UNITED STATES PATENT AND TRADEMARK OFFICE

APPLICATION NO.	FILING DATE	FIRST NAMED INVENTOR	ATTORNEY DOCKET NO.	CONFIRMATION NO.
10/588,536	08/07/2006	Fernando Garofoli	06170-PCT-PA (0030.0567)	9569
7590 09/02/2009				
ROBERT M. GAMSON HODES, PESSIN & KATZ, P.A. 901 DELANEY VALLEY ROAD, SUITE 400 Towson, MD 21204				
EXAMINER				
FULTON, KRISTINA ROSE				
ART UNIT		PAPER NUMBER		
3673				
MAIL DATE		DELIVERY MODE		
09/02/2009		PAPER

Office Action Summary

DETAILED ACTION

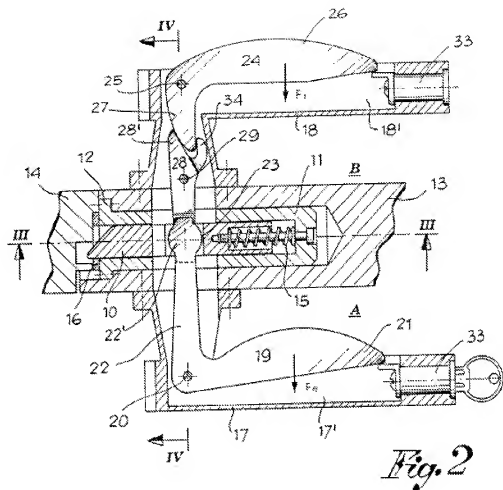
Claims 16 and 2-9 are rejected under 35 U.S.C. 103(a) as being unpatentable over Pedersoli (DE4009764) in view of Lin (US 5284372). "As best understood" Pedersoli shows internal and external handles (17 and 18) with L-shaped profiles having an upper (any top portion) and a lower (any bottom portion) portion further having an opening lever (22 or 27) and an opening button (26 or 21). The handle further include a vertical lever (28), a housing (11) and a latch mechanism (10). The handle further shows a hook (22') that activates the spring latch (10). Further, Pedersoli shows a finishing moulding (any part of the outside covering) used to cover a central junction line between upper and lower parts. See the Pedersoli device below.

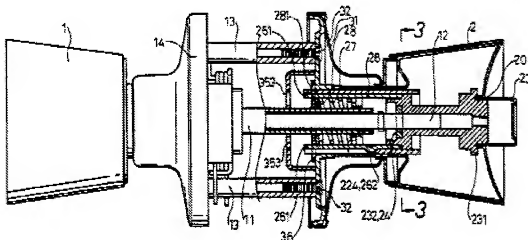
Perdersoli shows applicant's basic inventive concept but fails to include an ejection spring or pins and screws to attach to the door and other handle side. Lin shows these to be well known in the art. Lin shows an ejection spring (27) for pushing a button (23) outwardly. Further, Lin shows screws (32) for attaching to the door and pins (13) for attaching to the other side of the handle. It would have been obvious to one of ordinary skill in the art to include the spring of Lin on the Perdersoli device in order to assure proper positioning of the button and to include screws and pins for mounting in

order to hold the device in place during operation. Using screws and pins for mounting is extremely well known and common place in the art. See the Lin device below.
